工程指示 / 要求簡箋(E.I.)

工程指示編號：EI / 7137 / 24

工程名稱：將軍澳日出康城 11

工程項目：幕牆 T3 AA 室內收口 地盤用 共 20 件 工差室內收口

美特铝质有限公司 MIDI Aluminium Fabricator Ltd.		工程號	J858	類別		物料號	-
修改	A	採用工廠	地盤	康城11期	制圖	J.L.	2023-16-17
日期	16/08	材料顏色	ECD3X1009 9S-XF1	圖紙名稱	幕牆磚牆收口	復核	-
				材料	X86459	批准	-
						圖號	X86459-01
						數量	-
						單件重量	- (KG)

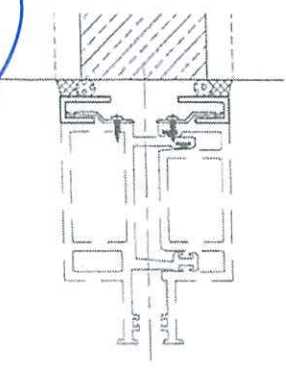
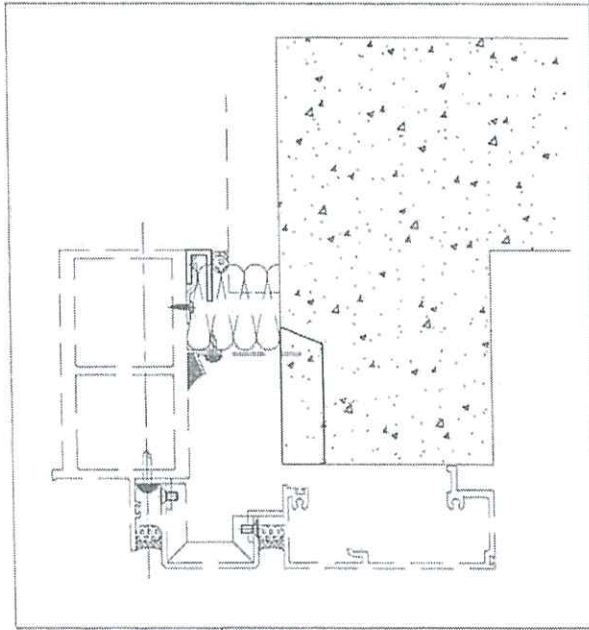
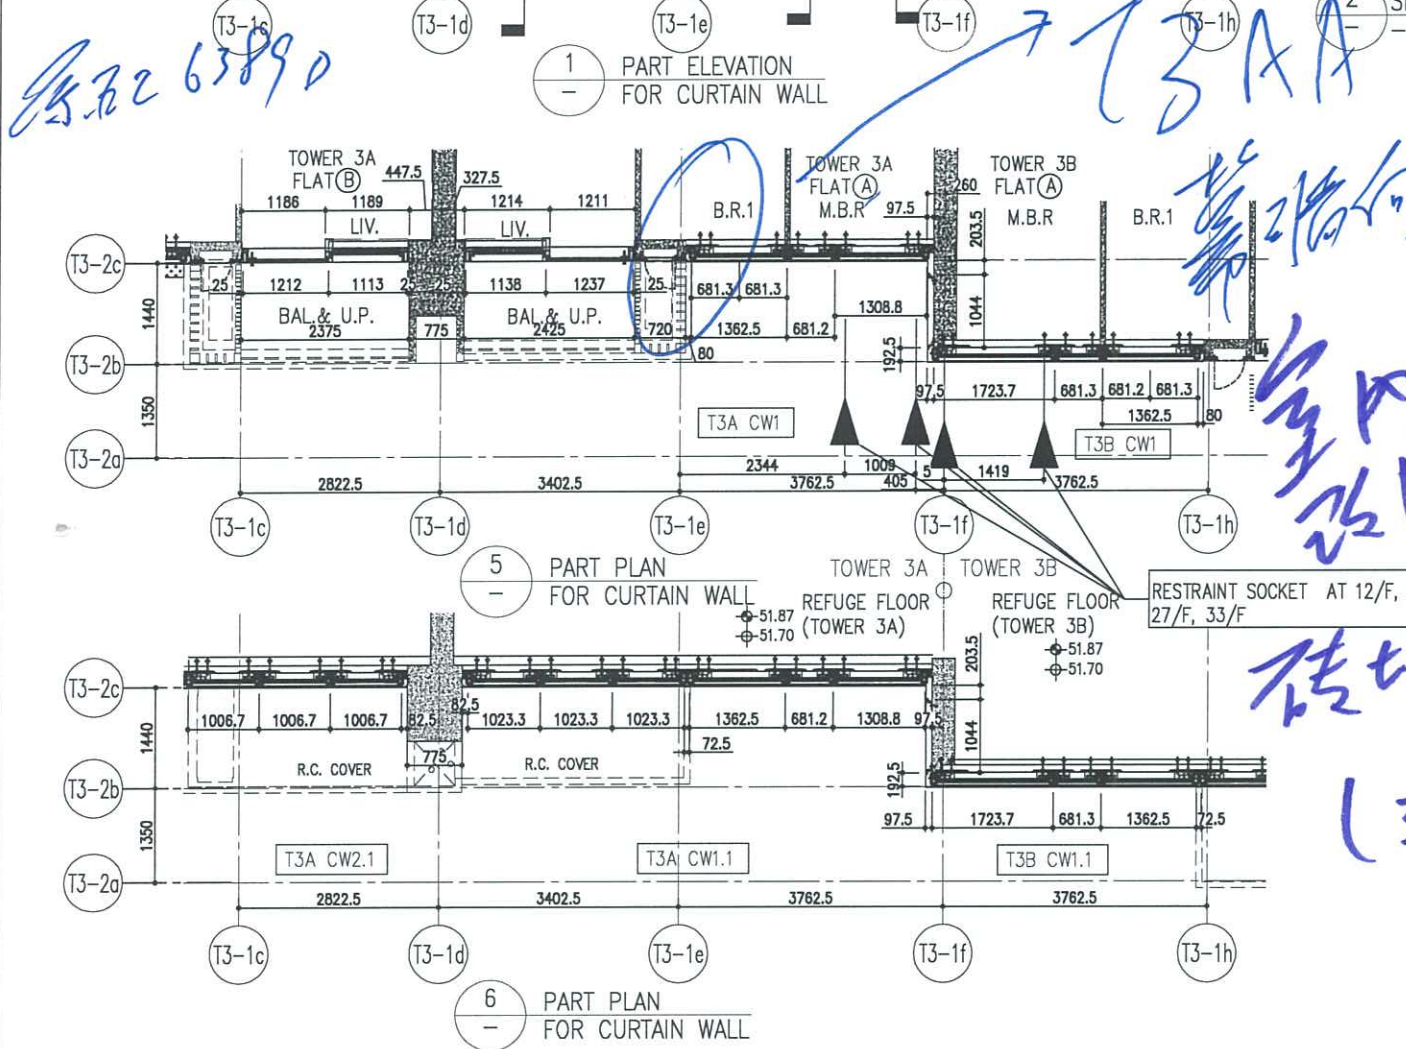
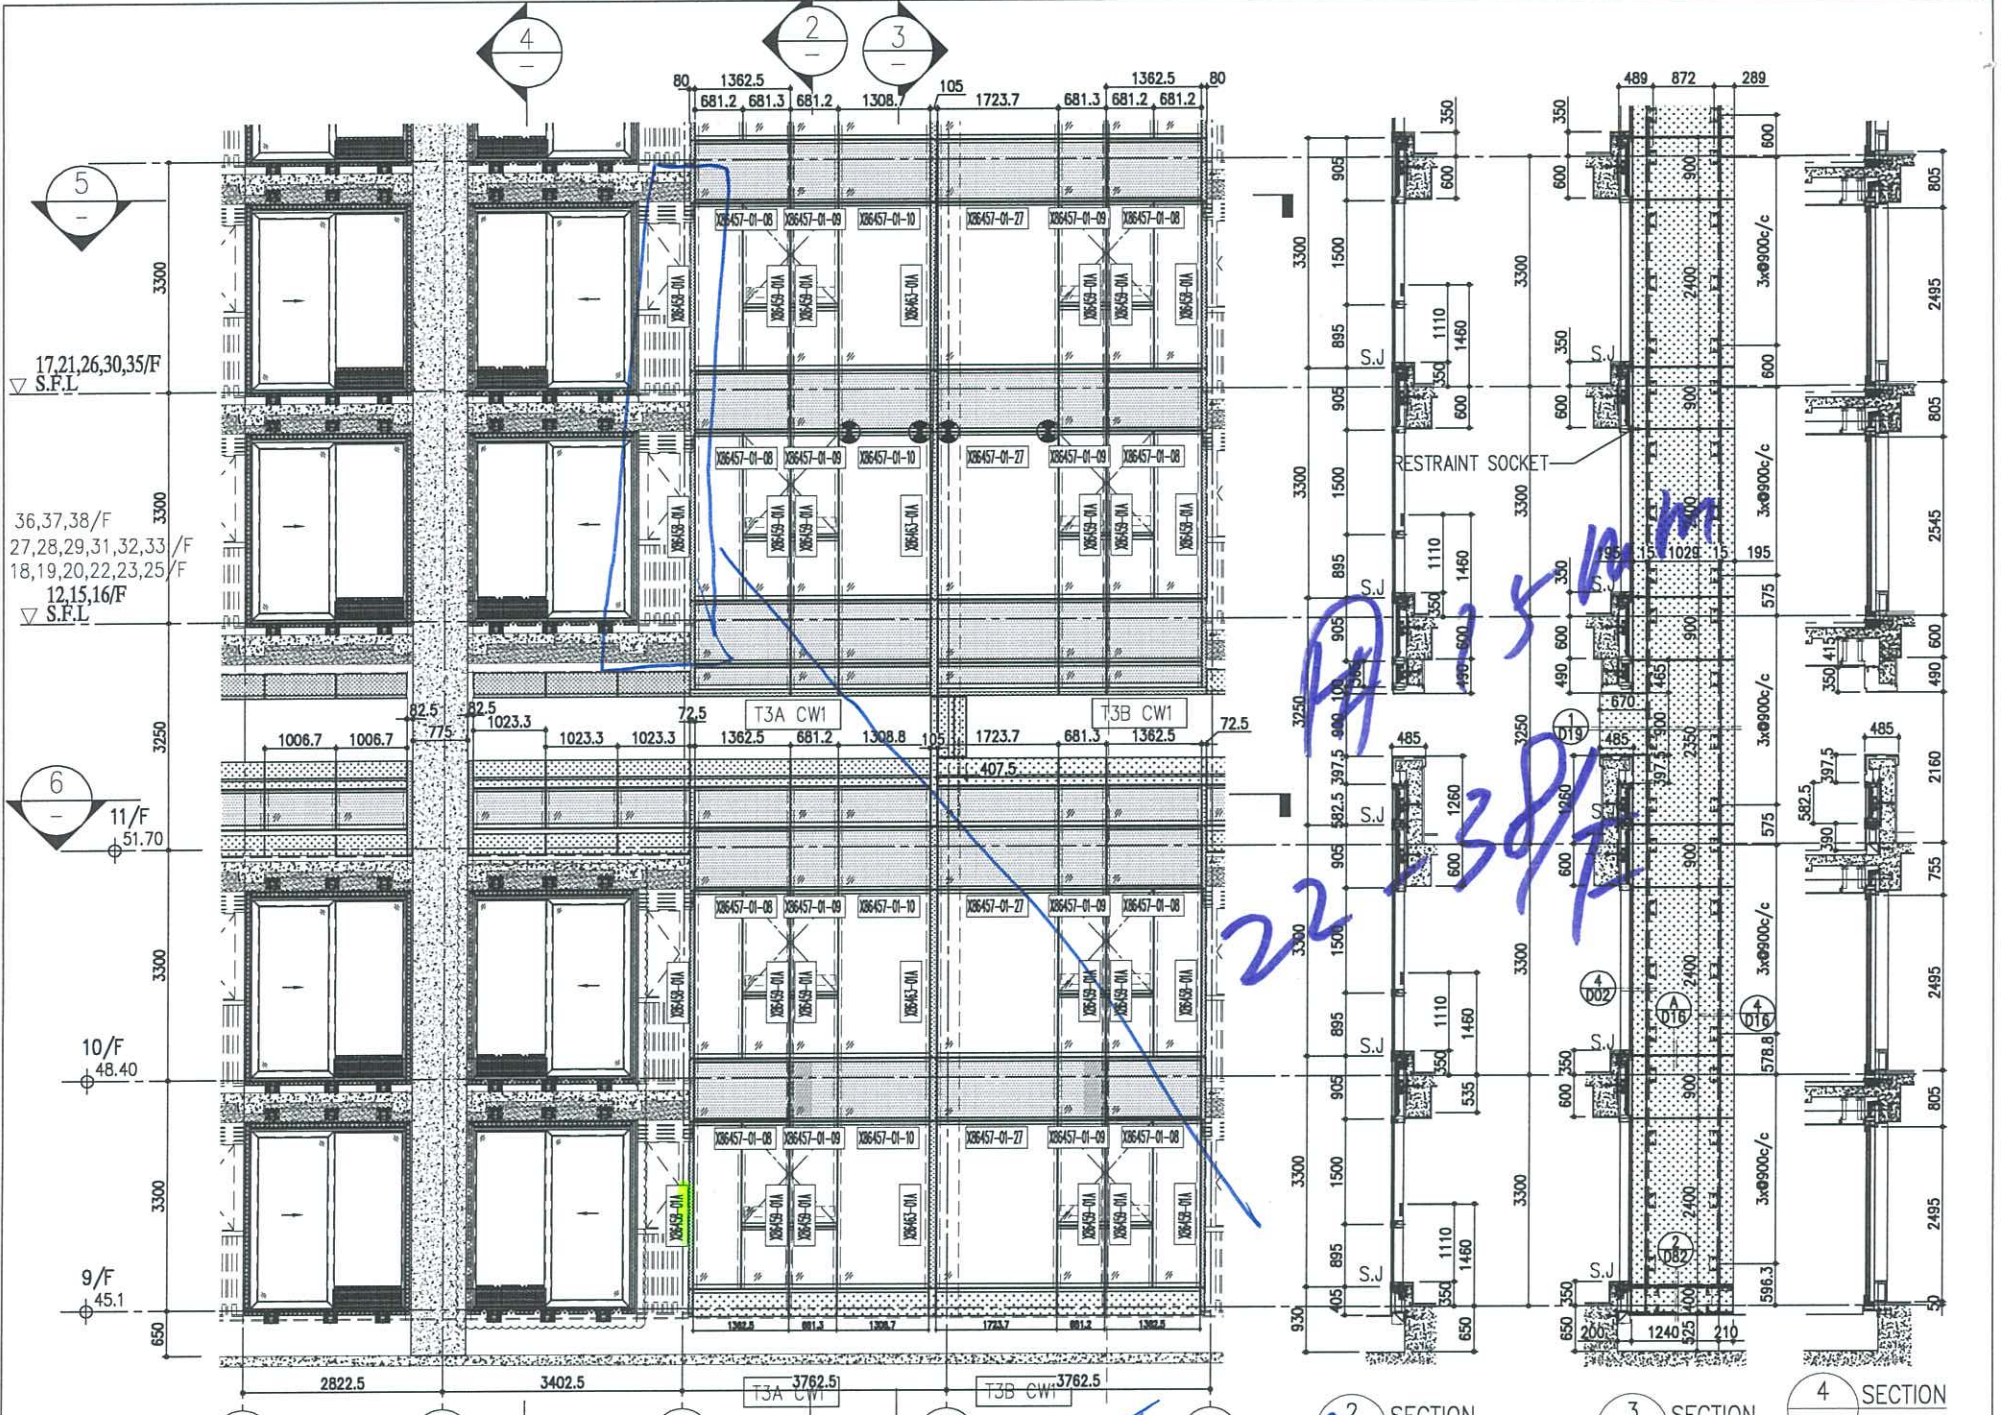
因應 T3 AA 幕牆單元安裝工差較大。 22/F - 38/F (15 層 加 5 層後備)

請按加工圖生產幕牆 T3 AA 工差室內收口 供地盆使用 共 20 件

X86459 - T3AA =20 件

15mm 款

工差單位用
T3AA

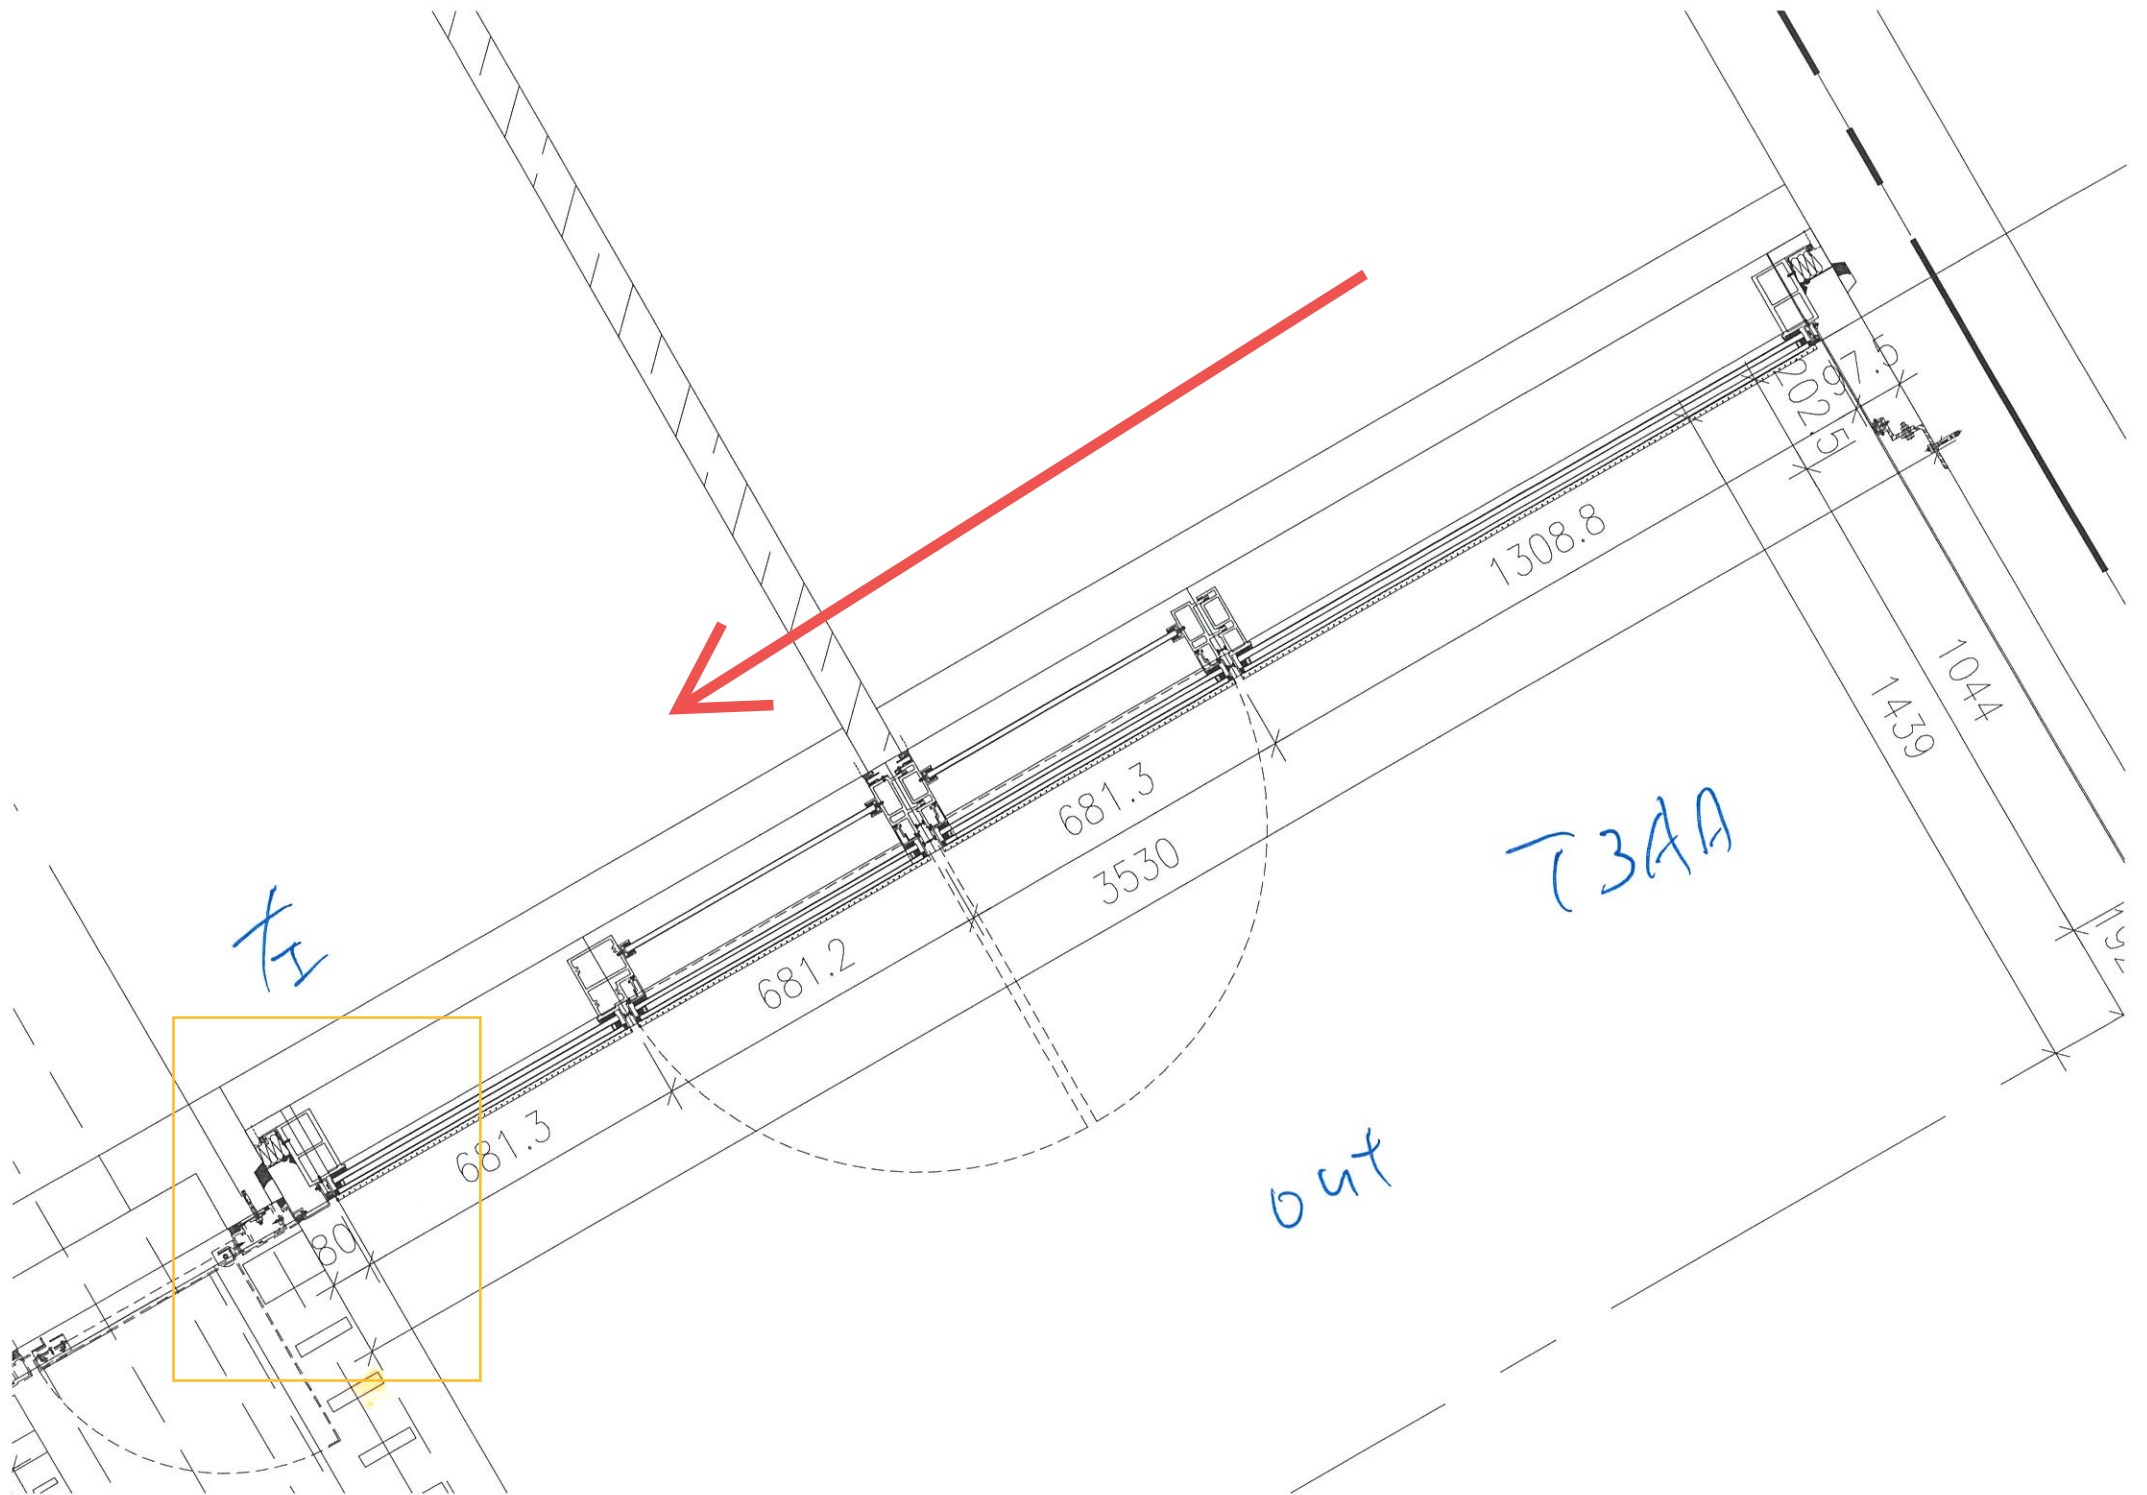
22-38/F 用15mm寬鋁板

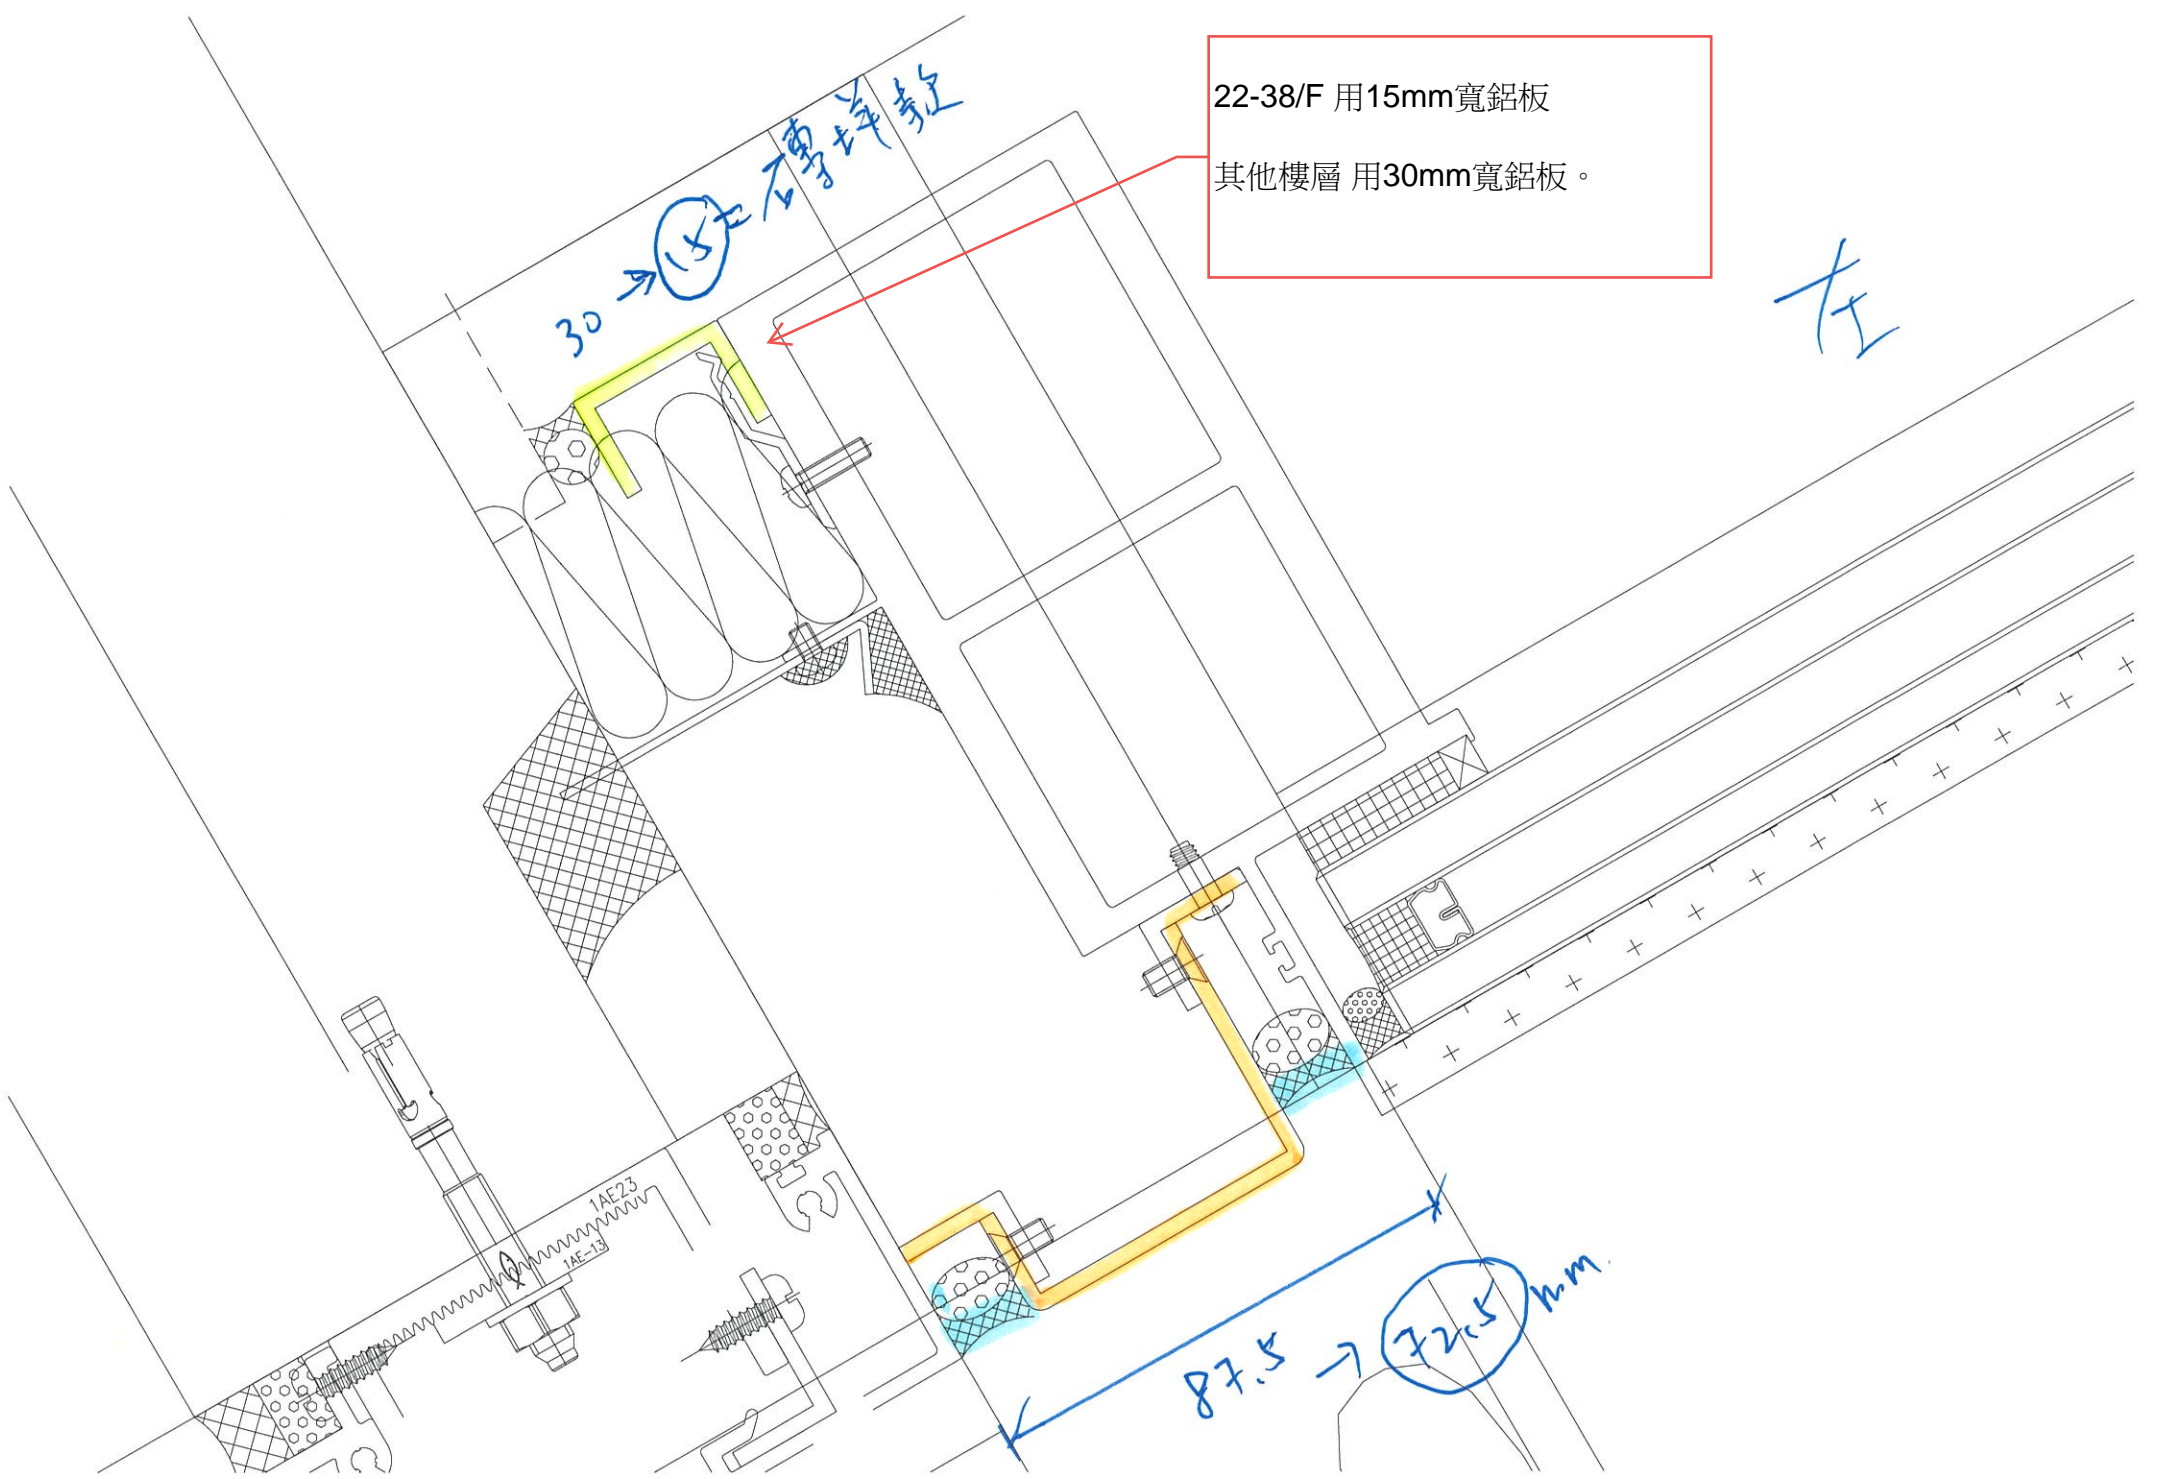
其他樓層 用30mm寬鋁板。

87.5 → 72.5 mm

22-38/F 用15mm寬鋁板
